File Number	PL 23-072	Contact	Kyle Deming	
Type	Variance – building height	Planning Commission Date		May 9, 2023
Deadline for Action	Application Date	April 4, 2023	60 Days	June 3, 2023
	Date Extension Letter Mailed	April 19, 2023	120 Days	August 2, 2023
Location of Subject		3801-3803, 3805-3807, 3809-3811 London Rd.		
Applicant	London East, LLC	Contact	Ted Stocke	
Agent		Contact		
Legal Description		Lots 17-22, Block 1, London East Division (010-3075-00170, -00180, -00190, -00200, -00210, -00220)		
Site Visit Date		April 24, 2023	Sign Notice Date	
Neighbor Letter Date		April 20, 2023	Number of Letters Sent	14

A variance to allow three twin homes (a form of two-family dwelling) to be constructed at 39.5 feet tall instead of the 30 feet maximum building height per UDC Section 50-14.5. The project is within the London East development which includes both single-family detached homes and twin homes.

**Recommended Action:** Approve with conditions.

PL 23-072

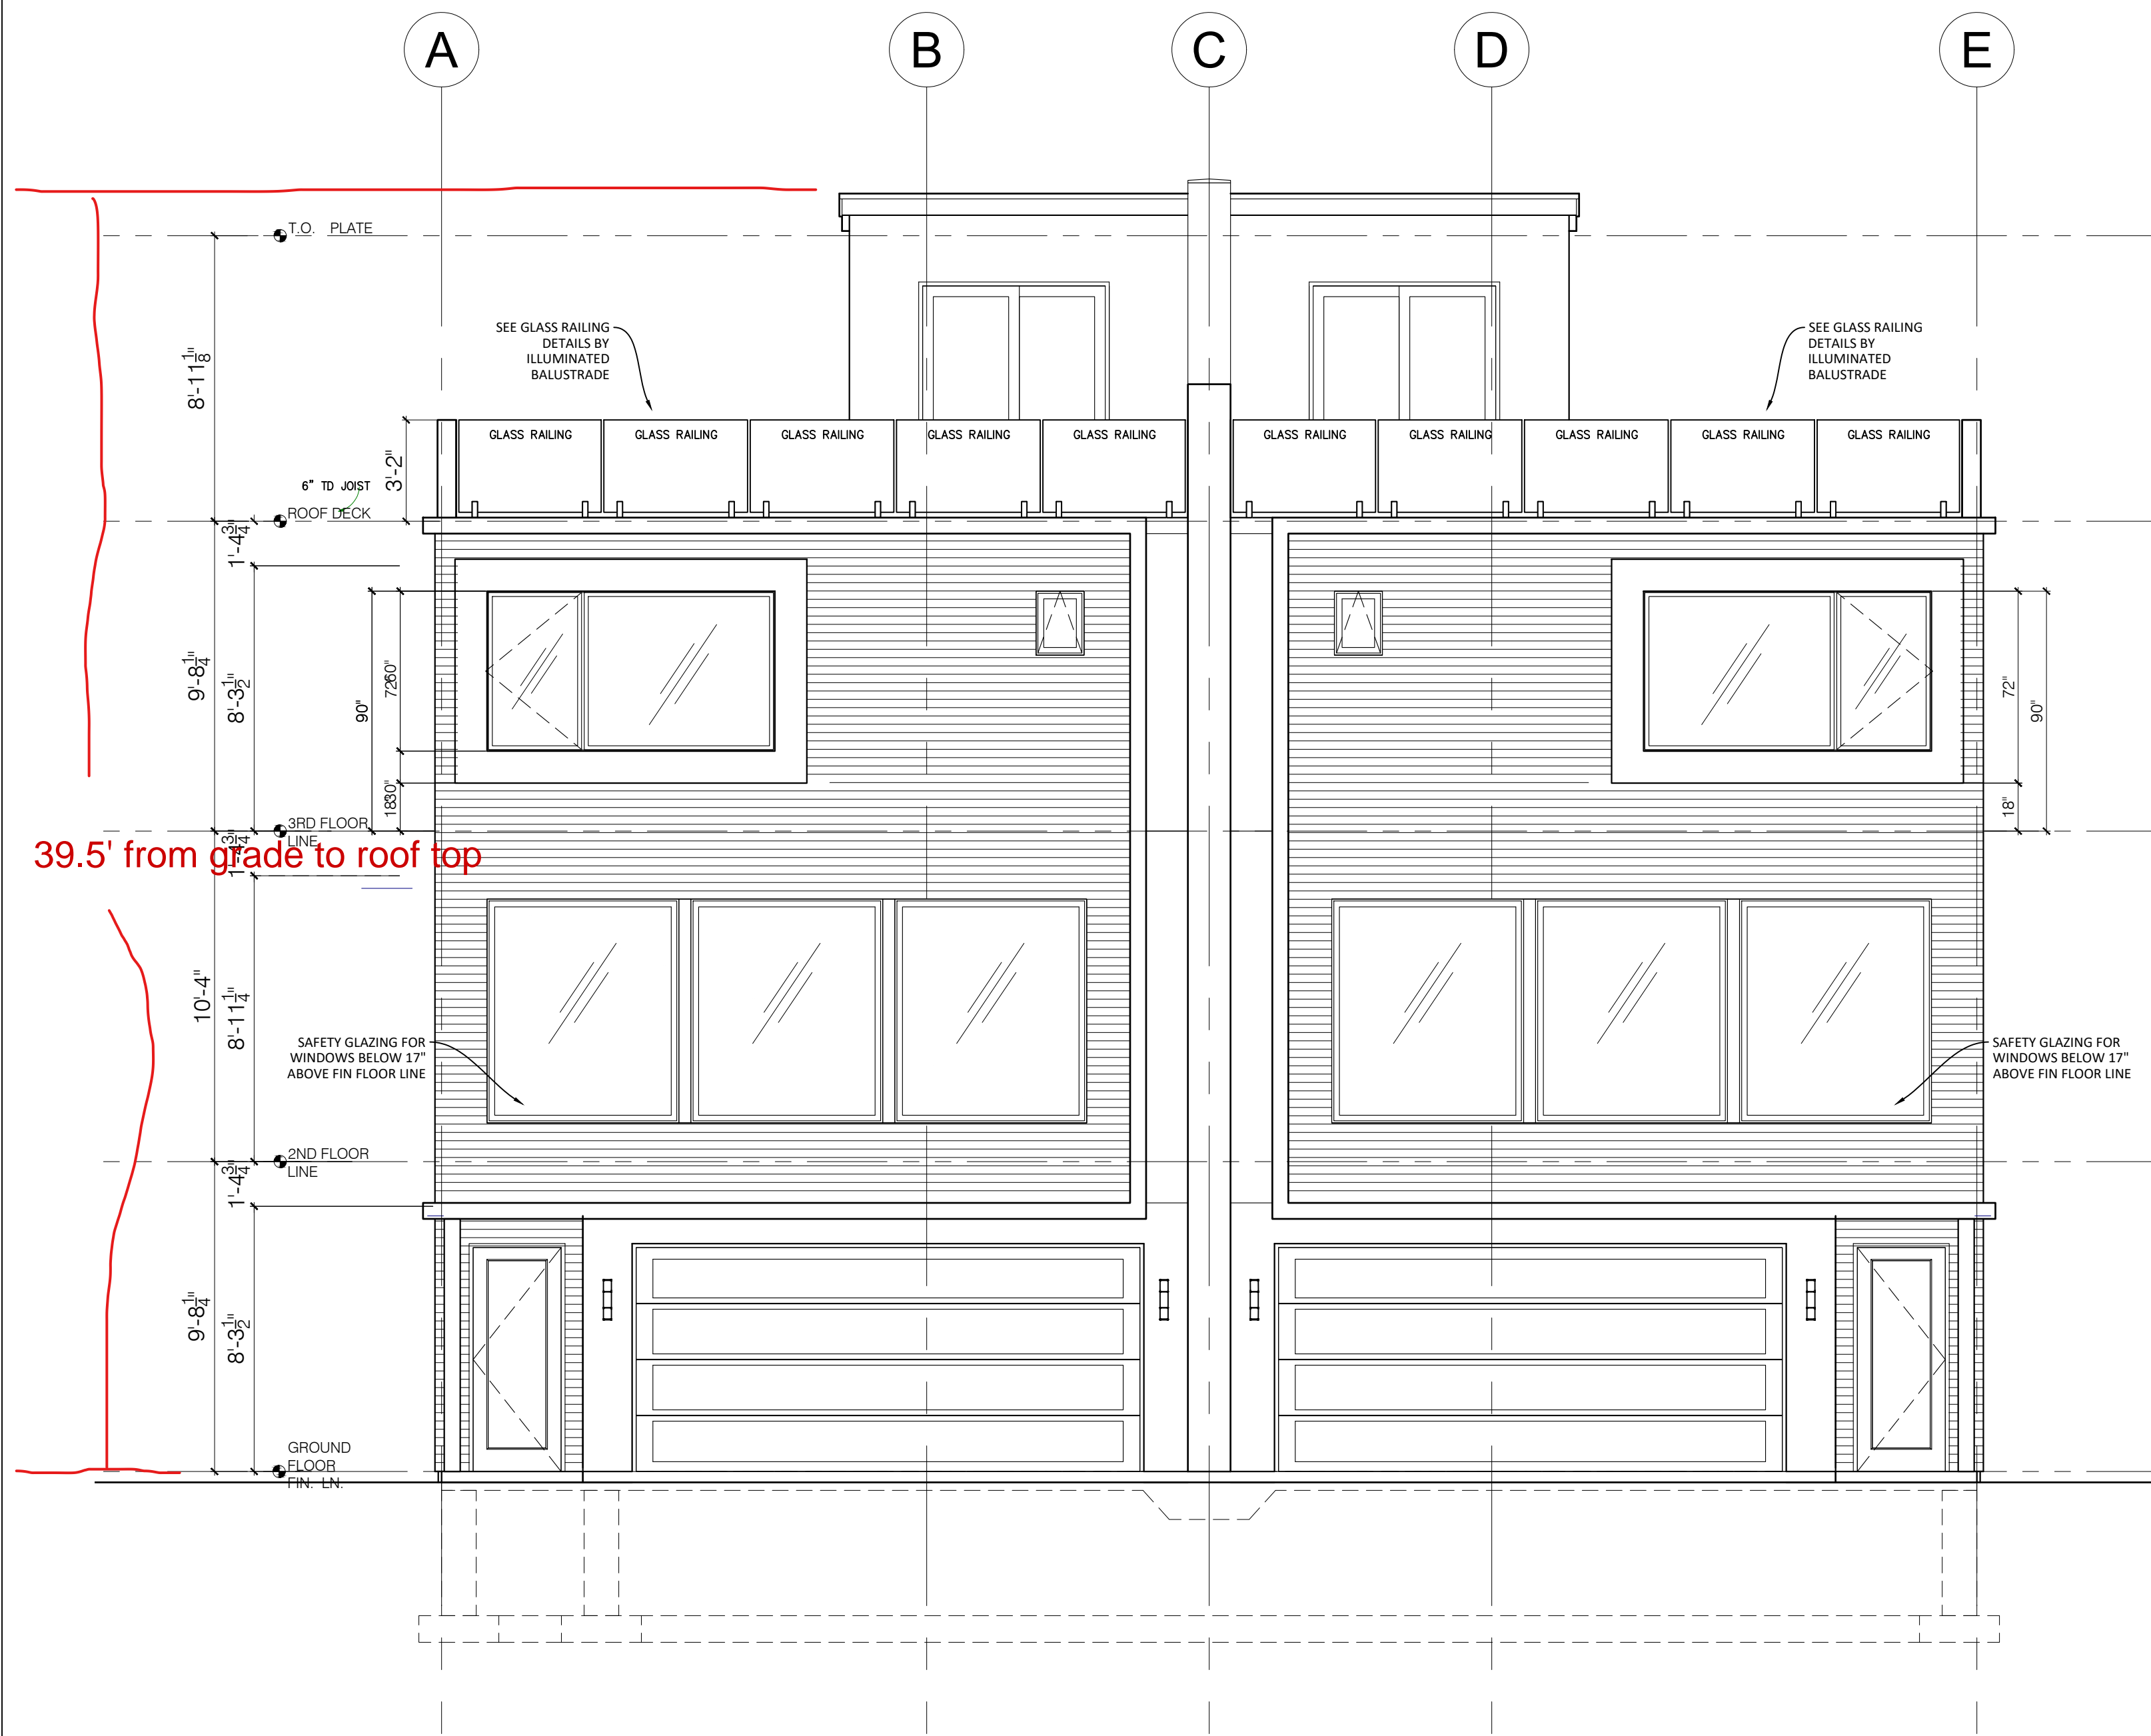
2. Applicant is proposing to construct 3 twin homes in the middle part of the development that would be 39.5 feet tall instead of the 30 feet allowed in the R-1 district. According to the plans, two parts of the building exceed the maximum height, a 22-foot-wide by 26-foot-deep enclosed space and an open terrace/deck with standard height fall protection walls or railings at the building perimeter.

7. Granting the variance will not alter the essential character of the area because the proposed 48-foot-wide, 39.5-foot-tall structures will have a similar bulk to the twin homes on the adjacent lots within the development. Additionally, across London Rd. are three large apartment buildings, one 170 feet long by 3 stories, one 270 feet long by 3 stories, and one 240 feet long by 6 stories tall. The recently completed Zvago condominium building is 4 stories tall and the Ecumen Lakeshore complex includes 3-story buildings of a similar height when including the steeply pitched roofs.

- 1) The project be limited to, constructed, and maintained based on the plans submitted with the application that shows the portion of the building exceeding the maximum height consisting of a 22-foot-wide by 26-foot-deep and an open terrace/deck with standard height fall protection walls or railings at the building perimeter.
- 2) Any alterations to the approved plans that do not alter major elements of the plan may be approved by the Land Use Supervisor without further Planning Commission; however, no such administration approval shall constitute a variance from the provisions of Chapter 50.
